UNITED STATES PATENT AND TRADEMARK OFFICE

APPLICATION NO.	FILING DATE	FIRST NAMED INVENTOR	ATTORNEY DOCKET NO.	CONFIRMATION NO.
10/555,816	11/07/2005	Robert Schegerin	41052/321928	2669
23370	7590	03/19/2008		
JOHN S. PRATT, ESQ KILPATRICK STOCKTON, LLP 1100 PEACHTREE STREET ATLANTA, GA 30309			EXAMINER DIXON, ANNETTE FREDRICKA	
			ART UNIT	PAPER NUMBER
			3771	
			MAIL DATE	DELIVERY MODE
			03/19/2008 PAPER

Office Action Summary

DETAILED ACTION

Exhibit A: Examiner modified Figure 3 of Stern (5,372,130)

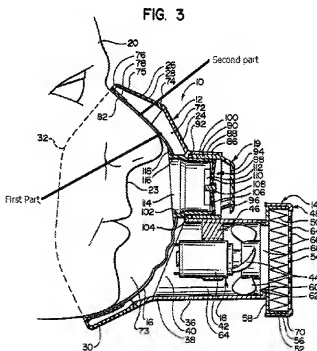
As to Claim 20, Stern discloses a respirator face mask (10) providing physiological protection, comprising: an oronasal face piece (24) which is connectable to a respiratory gas source (18), a semi flexible lip element (26) with an edge designed to position said oronasal face piece (24) on a user's face, and hygienic protection means (16) which are removably positioned (Column 6, Lines 15-17) at least partially inside said mask (10) and including a first part (Exhibit A) which provides hygienic protection and a second part (Exhibit A) which maintains said hygienic protection means in the mask, said second part cooperating with the semi-flexible lip element (26) and the face piece (24).

Yet, Stern does not expressly disclose the cooperation with the second part and the semi-flexible lip to be elastic. However, at the time the invention was made the use of

elastic cooperation with the second part and the semi-flexible lip was known.

Specifically, as the filter device (16) of Stern is capable of being removed from the mask (10) the filter device (16) may be replaced with any other device including but not limited to the device of Kaufman which includes a filter (1) in the first part of the filter and a seal (2) made of a plastic edge on the second part of the filter as Kaufman teaches a dual part filter medium for providing filtering to the first part and a sealing edge on the second part. The combination of these two references would result in the elastic connection of the second part and the sealing edge as both portions are made of plastic. (Figure 1, Column 2, Lines 40-63). Thus, it would have been obvious to one having ordinary skill in the art at the time the invention was made to modify the device of Stern to include a dual part filter medium as taught by Kaufman to provide additional sealing means of the mask to the user.
